## 28 - 32 DUMARESQ STREET GORDON -SUPPLEMENTARY REPORT

<b>PURPOSE FOR REPORT:</b>	To outline and address the response submitted by the applicant to the decision made by the Sydney West Joint Regional Planning Panel (JRPP) at the meeting of the 27 February 2014 and for the JRPP to determine DA0501/12 for 34 apartments, basement car park and landscaping.
<b>BACKGROUND:</b>	An assessment report was prepared and considered by the JRPP on 27 February 2014 where the JRPP resolved to defer the determination to enable the applicant to further explore the opportunity to achieve a development that addresses the shortfall in car parking spaces, but at the same time comply with deep soil landscaping and on-site waste/garbage vehicle manoeuvring requirements without the need to delete any residential units.
<b>COMMENTS:</b>	The applicant has responded to the decision of the JRPP by presenting three (3) options. The resolution of the JRPP was not to prepare or have considered multiple options and subsequently the applicant's preferred option has been considered.

**Figure 1 – Deep soil calculations**

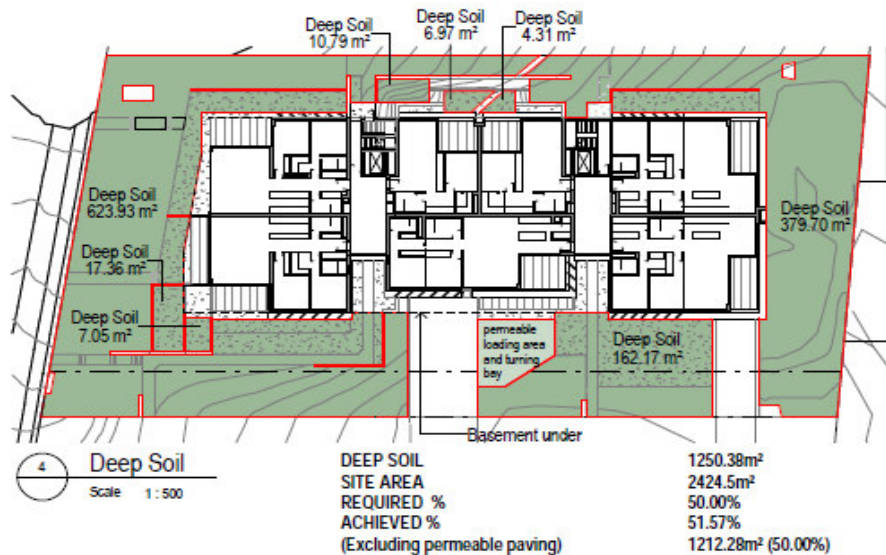
**Annexure B and Figure 1** below, an extract of a plan entitled "Setback Zones, Deep Soil, Common Open Space" prepared by the applicant demonstrates that the proposal achieves 1212.28m<sup>2</sup> of deep soil landscaping which equates to a ratio of exactly 50%. The scale of this plan at 1:500 makes verification of the deep soil landscaping calculation very difficult. The applicants' calculation is therefore not accepted as:

- deep soil landscaping figures cannot be confirmed by submitted revised plans given the scale of the plans;
- the likely need for a retaining wall along the northern boundary of the private courtyard of Apartment 9 to achieve a reasonable grade for landscaping between the proposed substation and this courtyard
- inconsistencies between the revised plans submitted to Council

Furthermore, the permeable loading area and turning bay is excluded from deep soil landscaping calculations as shown in **Figure 1**, as it is considered not to be deep soil landscaping because it cannot be landscaped with planting of suitable trees or shrubs that would facilitate the creation of a landscaped setting for the site that satisfies the relevant objectives of the KPSO. If hardstand area was deleted and a loading area and turning bay provided as suggested in the original assessment report, this area could positively contribute to the total amount of deep soil landscaping provided on site and the site would achieve more than the 50% deep soil required by the controls.

Refer to comments above. As previously stated, the proposed turning area and loading bay is excluded from deep soil calculations. The proposal claims 50% or 1212.28m<sup>2</sup> of deep soil landscaped area, however this figure is questionable as additional retaining walls are necessary, affecting the deep soil calculation. Whilst this turning area has been minimised in size to reduce its impact, it will still present as a significant open paved area providing little amenity to the site and streetscape, particularly to Apartment 3 given that limited landscaping is provided adjacent to this apartment.

Figure 2 – Extract of Landscape Plan

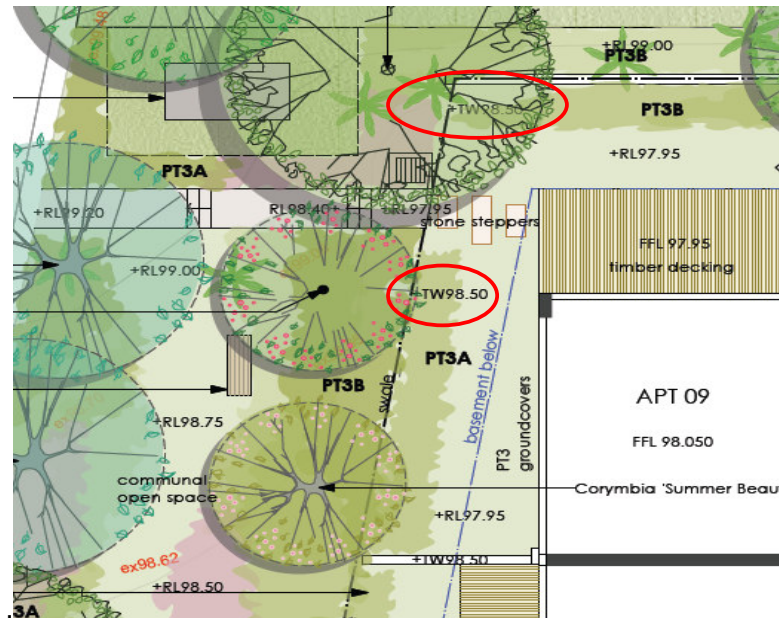
The suggested amendment of Condition 20 to refer to the landscape plan submitted prior to the JRPP meeting of 27 February 2012 is not supported as the revised landscape plan dated 25.02.14 contains anomalies with other plans. This revised landscape plan depicts the retention of a retaining wall (i.e. **Figure 2** below) adjacent to the northern boundary of the courtyard to be attached to Apartment 9 whilst the amended deep soil landscape calculations plan (i.e. **Figure 1** above) and the revised stormwater plan show removal of this retaining wall (**Annexure D**). Consequently, there are inconsistencies between plans and no certainty as to the position and location of retaining walls or the actual amount of deep soil.

The likely need for this retaining wall will result in a further reduction of deep soil landscaping by approx. 7m<sup>2</sup> which would then result in deep soil landscaping being less than 50% as required by KPSO. Alternatively, if it is the applicant's intention to delete this retaining wall then a cross section should have been prepared, taken from the north-east corner of the private courtyard of Apartment 9 including the proposed substation, to demonstrate that reasonable grades can be achieved for planting, including a canopy tree as shown on the landscape plan. This matter has been identified by both Council's Landscape and Engineering officers. The applicant to date has not provided this level of detail which further questions whether the development proposal complies with the 50% deep soil landscape control. Therefore, Condition 20 should be retained so that further details can be provided to demonstrate compliance with the deep soil landscape controls of the KPSO.
